Coastal Works Review

Demolition of existing dock & construction of new dock

Blossom Village Dr, Little Cayman

Ref: DOE/CWK/368

Figure 1: Plan extract showing the proposed dock
 (Source: TAG 2019, LIS 2013)

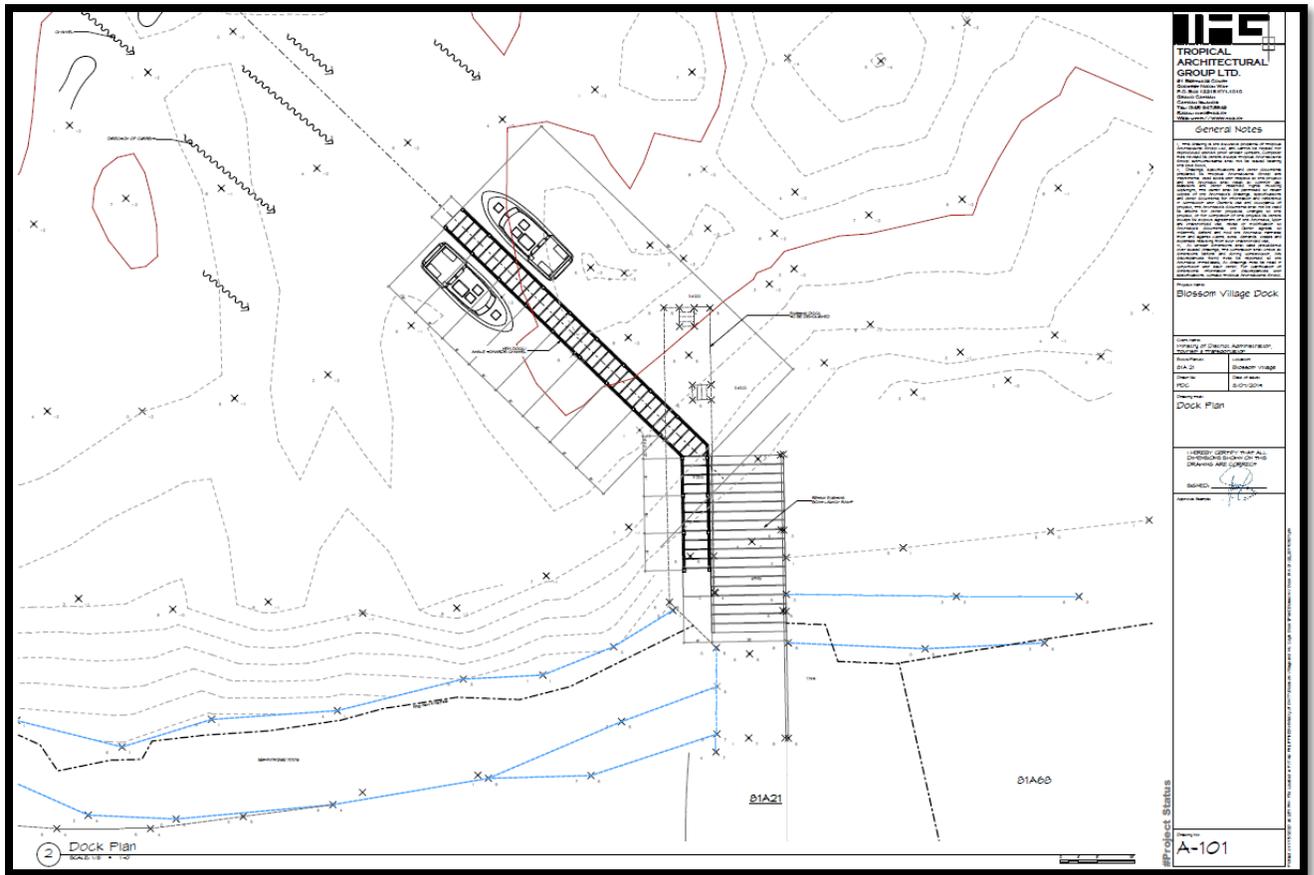
term shading caused by the dock structure which reduces vital light penetration required for seagrass growth and productivity. Seagrass is an important feature and contributor to the health of the marine ecosystem by providing living habitat, food and oxygen to marine fauna. Seagrass also plays a vital role in maintaining good water quality and providing some coastal buffering to mitigate the erosional effects of wave energy. The Department supports the applicant's proposal to install decking positioned 4 feet above mean sea level, with spacing of ½ inch as currently shown on the application plans.

The Department notes that during periods of high influxes of Sargassum, docks that have side skirting tend to trap and hold in place Sargassum, compared those docks that have no skirting and is at the recommend height of 4ft above mean sea level. From the plans, the dock appears to have side-planking but there is a gap of 1ft between the side-planking and the water level. The DoE recommends that the side-planking is positioned as high above sea level as possible.

We note that the applicant's submission does not indicate the use of any lighting on the dock at this time. Should the applicant wish to add lighting in the future, we recommend that any lighting proposed for the dock is turtle friendly and the following condition should be attached to the coastal works permit.

The applicant shall prepare and submit a plan to the Department of Environment for turtle friendly lighting, which minimises the impacts on sea turtles. All lighting shall be installed in accordance with the plan, to be approved by the DoE. Guidance on developing a lighting plan can be found in the DoE's Turtle Friendly Lighting: Technical Advice Note (September 2018).
